Re: HPB 23-0574 -- Ritz/Sagamore Certificate of Appropriateness Application for Properties at 1 Lincoln Road and 1671 Collins Avenue.

The owners/developers of the Ritz-Sagamore Project properties have applied for a Certificate of Appropriateness (COA) for renovations of the Sagamore Hotel, a one-story rooftop addition, porte-cochere and elevator at the Ritz Carlton Hotel, an elevated bridge between the two hotels, a 15-story residential tower to be situated behind the Sagamore Hotel, and site modifications. An application for a COA was submitted for a similar project in 2021. That application was not approved by the HPB.

Figure 9. Proposed Site Plan for Ritz-Sagamore Project. (Kobi Karp Architecture and Interior Design, Inc., Drawing A1.50, 5/8/2023)

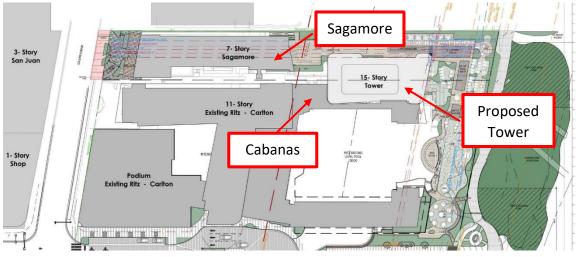
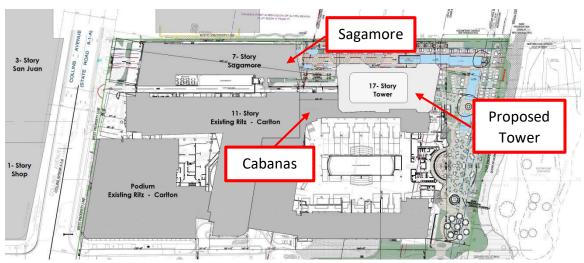
The Ritz-Sagamore Project proposes the construction of a 15-story, 182'-10" (202'-10" overall) tower behind the 7-story Sagamore Hotel. In 2019, the maximum building height for additions on lots of 115,000 square feet or greater was increased to 200 feet for RM-3 zoned oceanfront properties between 16th and 21st Streets. The subject properties, with combined lot sizes, meet the lot size criteria. The tower would be cantilevered over the cabanas located to the east of the Ritz-Carlton Hotel. (Figure 9)

The previous iteration of the project, from 2021, featured a 17-story, 200' tower (224'-0" overall) behind the Sagamore Hotel. The tower was to be cantilevered over the Ritz Carlton cabanas. (Figure 10)

Figure 13. East elevation of proposed tower. (Kobi Karp Architecture and Interior Design, Inc., Drawing A4.32, 5/8/2023)

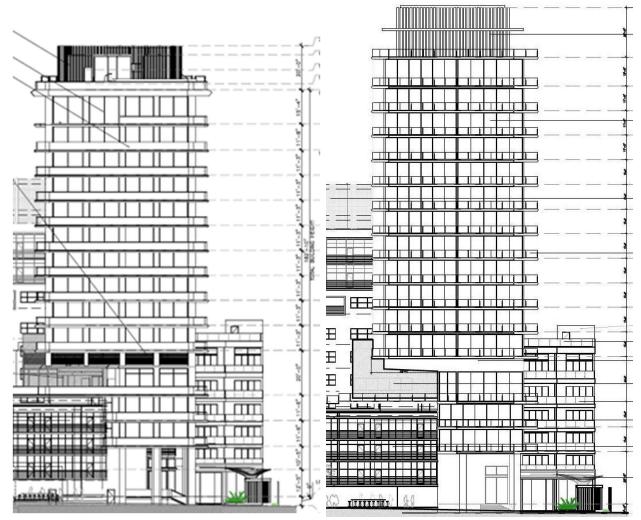
The overall height of the current proposed tower is 202'-10". The overall height of the tower in the 2021 proposal was 224'-0", a difference of 21'-2". (Figure 13, Figure 14)

The height to the top of the habitable space in the current proposed tower is 182'-10". The height to the top of the habitable space in the 2021 proposal was 200'-0", a difference of 17'-2".

Figure 44. Existing shadowing at Equinox, 10 a.m. (Heritage Architectural Associates with K4 Architecture)

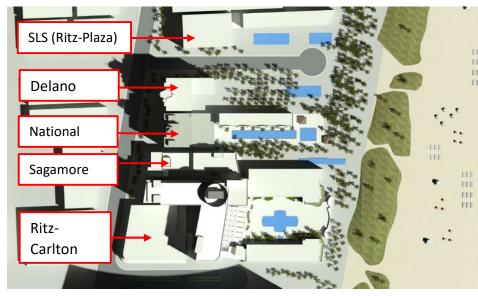
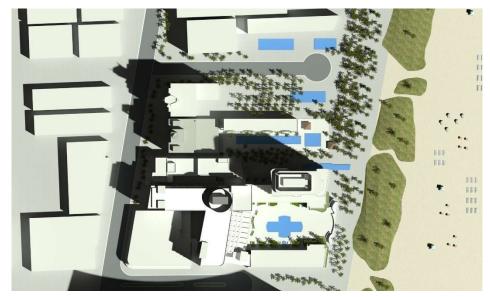
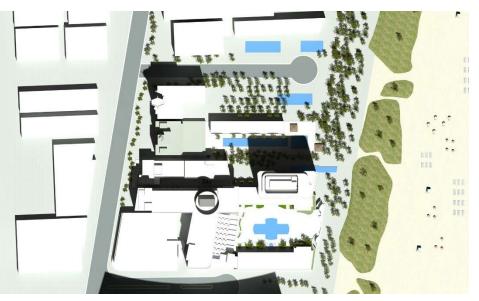
According to the solar shading studies shown, the addition of a 202'-10" building on the adjacent lot behind the Sagamore will have a significant impact on the National Hotel and will cast shadows on the pool area from approximately 10 a.m. until 3 p.m. during the Equinoxes, which was also the case with the 2021 proposed project. (Figure 44-Figure 55)

Figure 56. Existing shadowing at Winter Solstice, 10 a.m. (Heritage Architectural Associates with K4 Architecture)

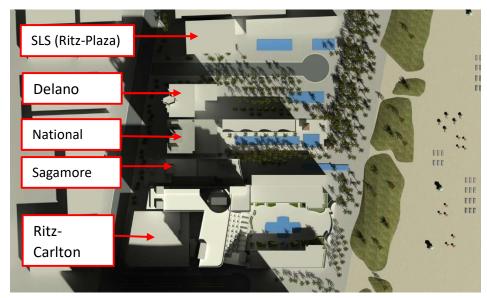
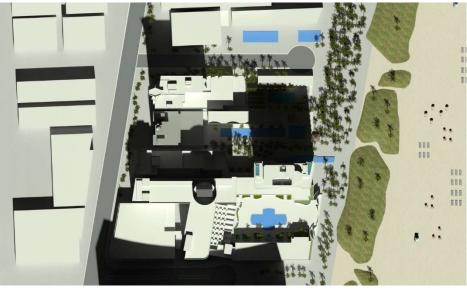
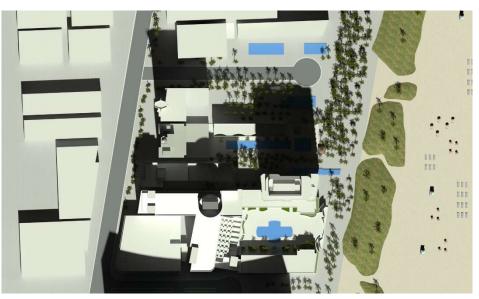
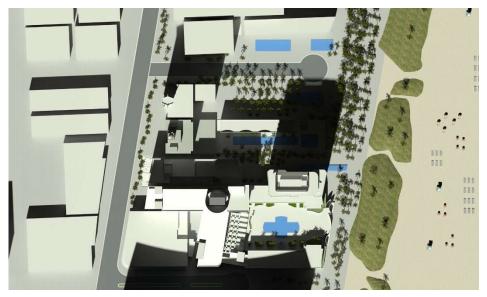
Significantly, the pool area at the National will be enveloped in shadows cast by a 202'-10" building during most of the day at the Winter Solstice, a time of year when occupants will be expecting sun in these light-inspired areas. The studies also show that the pool area at the Delano Hotel, two doors away from the Sagamore, will be in shadows cast by the 202'-10" tower from 11 a.m. after 2 p.m. during the Winter Solstice. (Figure 56-Figure 73) This was also the case with the 2021 proposed project.

In a district in which the design response to light is an essential component of historic architectural fabric, the adverse impact of giant shadows upon contributing buildings is significant. This impact strikes at one of the essential characteristics of the historic architecture of Miami Beach.
